APPLICATION FOR VARIANCE
Curb cuts/sidewalks

3. Describe the project (e.g. complete reconstruction of Rt. 20 from Main St. to Broadway):
The proposed project is MassDOT Project Number 608605: ADA Retrofits to Curb Ramps along State Highway Layout at Various Locations in the Municipalities of Medford, Somerville, and Woburn

ARCHITECTURAL ACCESS BOARD VARIANCE REQUEST

District 4 ADA Retrofits at Various Locations

MCGRATH HIGHWAY AT POPLAR STREET
SCALE 1 INCH = 30 FEET

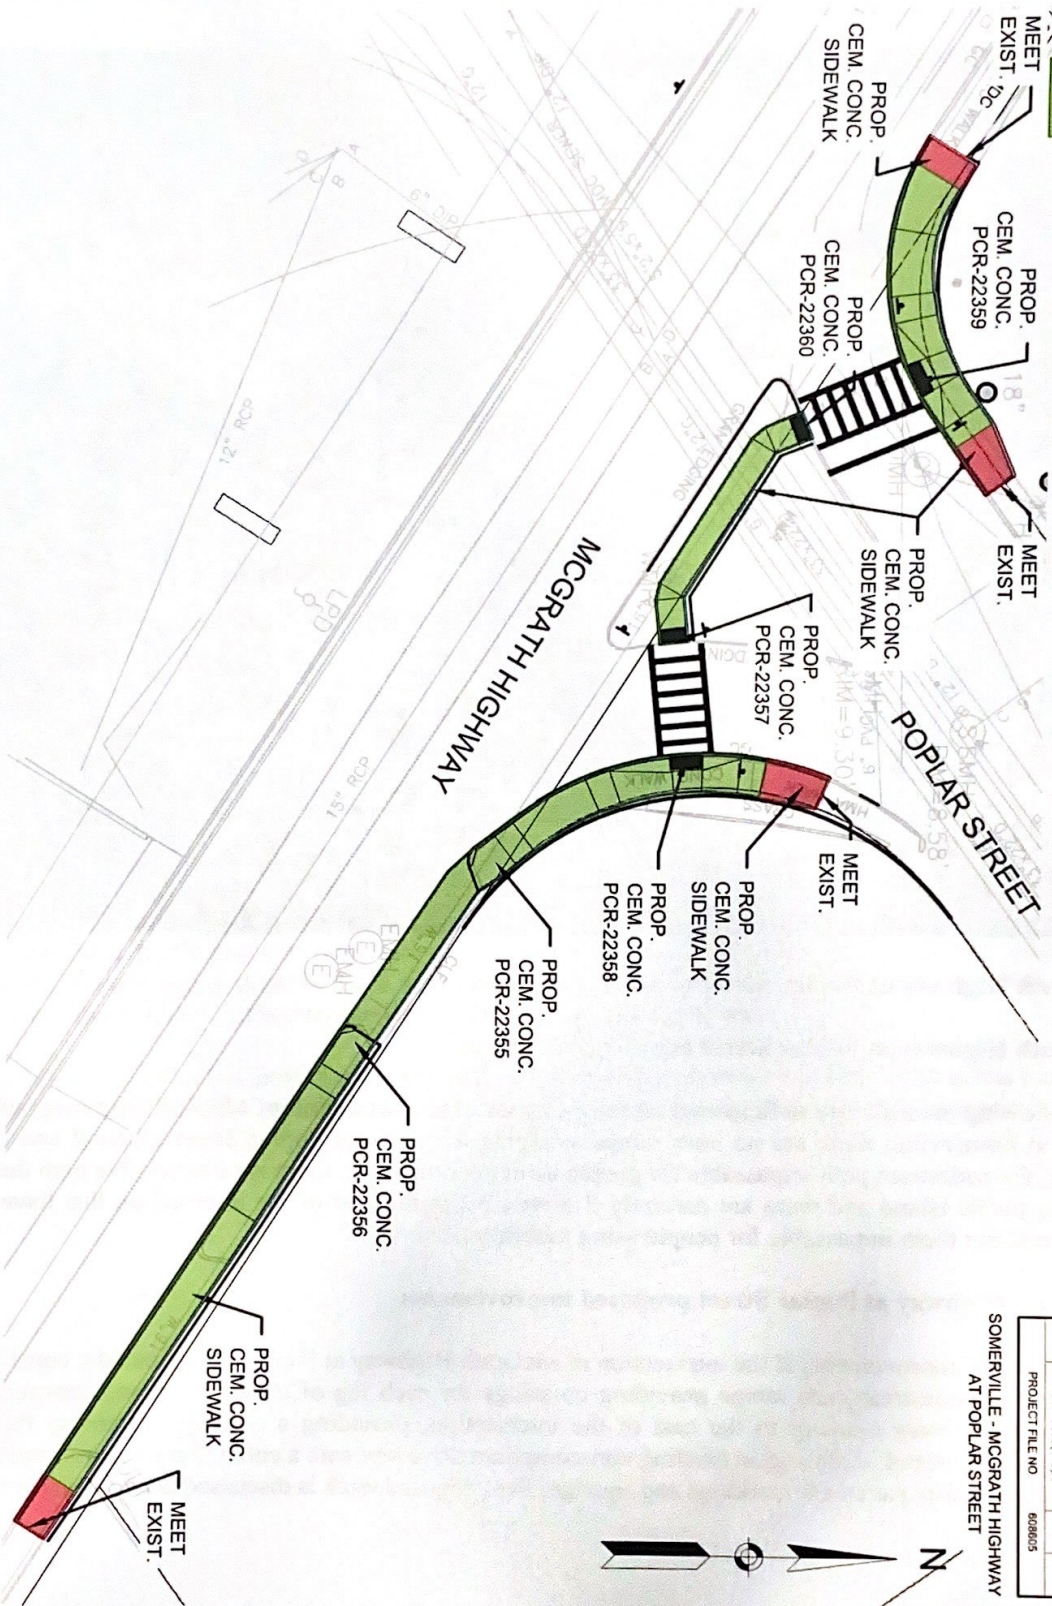
The following accessibility deficiencies currently exist at the intersection of McGrath Highway and Poplar Street in Somerville: there are no curb ramps available for crossing Poplar Street inbound and outbound making the pedestrian path impassable for people using mobility aids; there is no accessible path through the existing traffic island and there are currently 2 driveways to the east of the intersection that have no curb ramps making them impassable for people using mobility aids.

The proposed improvements at the intersection of McGrath Highway at Poplar Street include: construction of 6 compliant pedestrian curb ramps providing crossings for each leg of the intersection; construction of a compliant driveway opening to the east of the intersection; providing a compliant pathway through the existing traffic island; replacing an existing non-compliant driveway with a compliant sidewalk; and installing new high visibility pavement markings and signage. The proposed work is discussed in detail on the following pages.

PCR 22356
 SCALE: 1"=5'

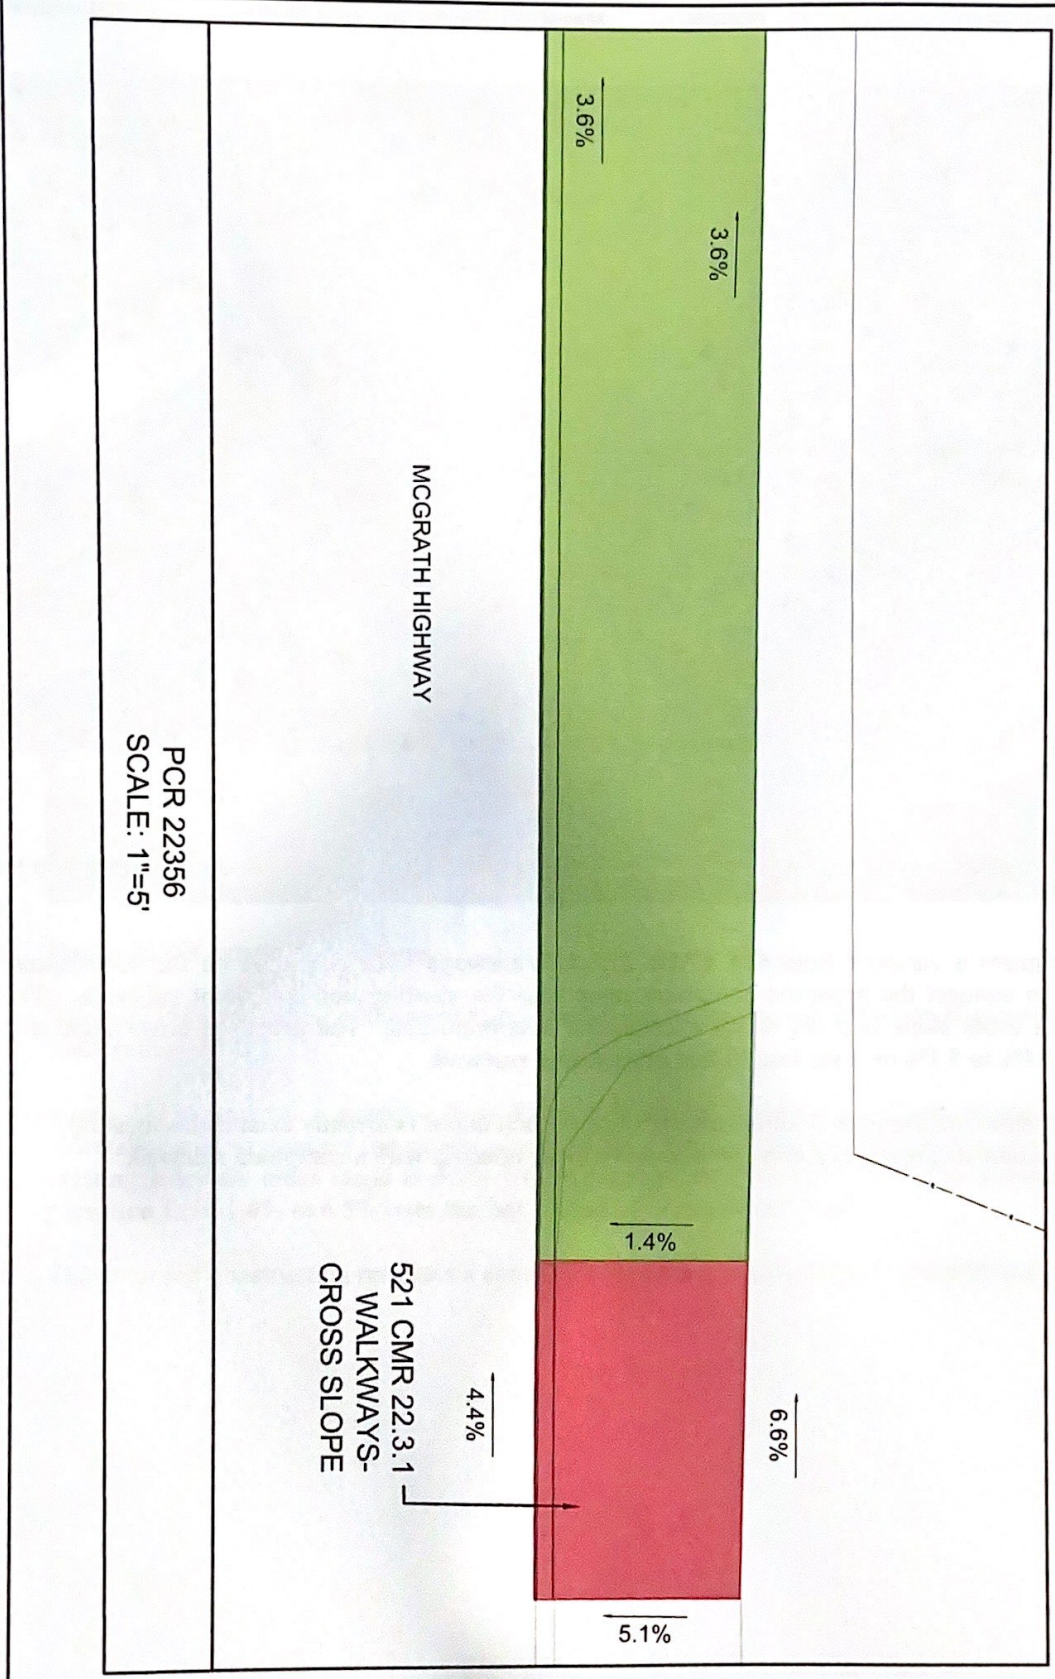
Ramp 22356 requires a variance from **521 CMR 22.3.1 Walkways – Cross Slope** on the easternmost sidewalk panel to connect the proposed compliant ramp into the existing non-compliant sidewalk. The existing sidewalk cross slope is 5.1% which exceeds the maximum 2%. The proposed cross slope will transition from 1.4% to 5.1% over the last 10 feet of proposed sidewalk.

The proposed construction provides a compliant curb ramp which doesn't currently exist at this location. The proposed construction also replaces a non-compliant driveway opening with a compliant sidewalk.

PCR 22358
SCALE: 1"=5'

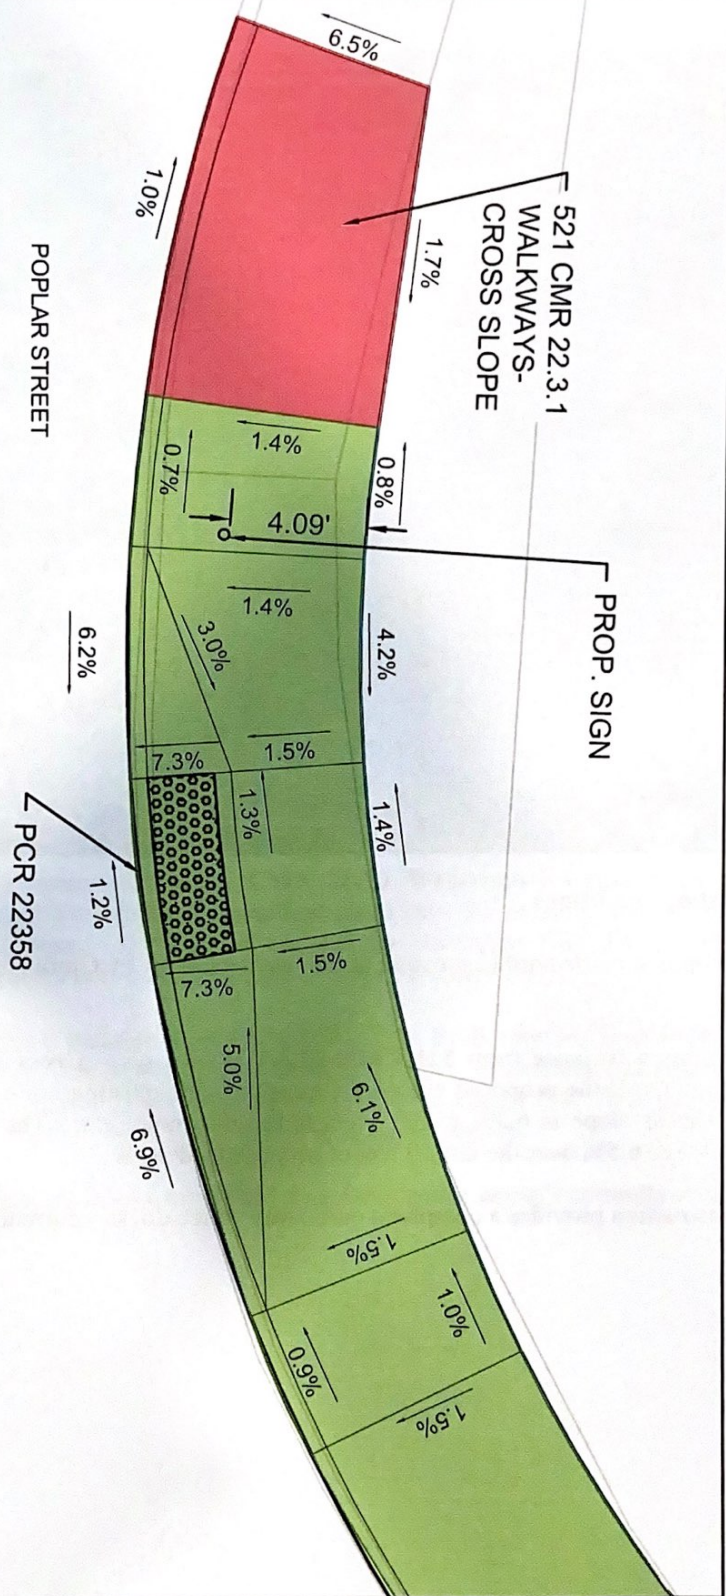
Ramp 22358 requires a variance from **521 CMR 22.3.1 Walkways – Cross Slope** on the northernmost sidewalk panel to connect the proposed compliant ramp into the existing non-compliant sidewalk. The existing sidewalk cross slope is 6.5% which exceeds the maximum 2%. The proposed cross slope will transition from 1.4% to 6.5% over the last 10 feet of proposed sidewalk.

The proposed construction provides a compliant curb ramp which doesn't currently exist at this location.

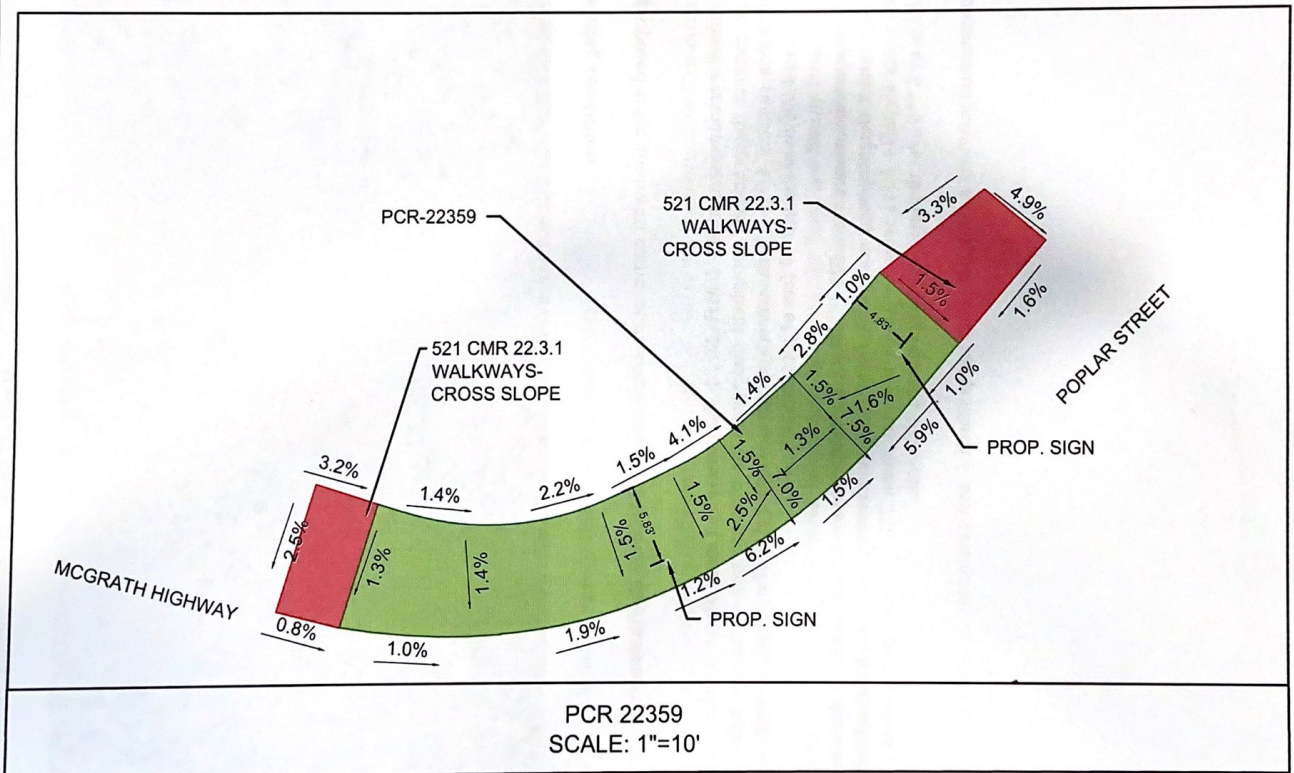
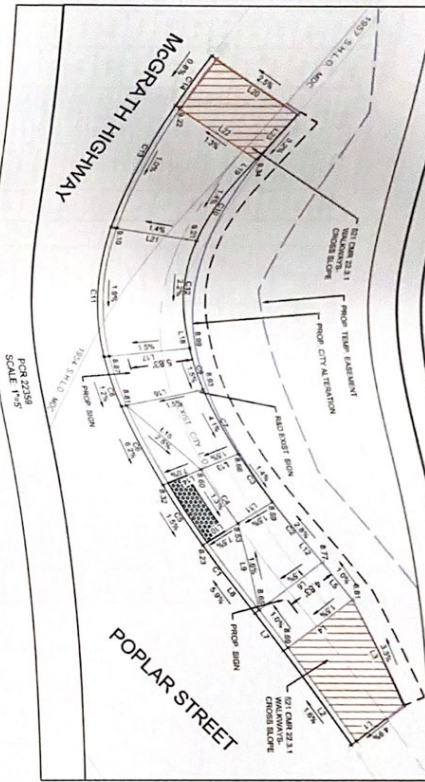
Ramp 22359 requires a variance from **521 CMR 22.3.1 Walkways – Cross Slope** on the northernmost sidewalk panel to connect the proposed compliant ramp into the existing non-compliant sidewalk. The existing sidewalk cross slope is 4.9% which exceeds the maximum 2%. The proposed cross slope will transition from 1.5% to 4.9% over the last 10 feet of proposed sidewalk.

Ramp 22359 also requires a variance from **521 CMR 22.3.1 Walkways – Cross Slope** on the westernmost sidewalk panel to connect the proposed compliant ramp into the existing non-compliant sidewalk. The existing sidewalk cross slope is 2.5% which exceeds the maximum 2%. The proposed cross slope will transition from 1.3% to 2.5% over the last 5 feet of proposed sidewalk.

The proposed construction provides a compliant curb ramp which doesn't currently exist at this location.
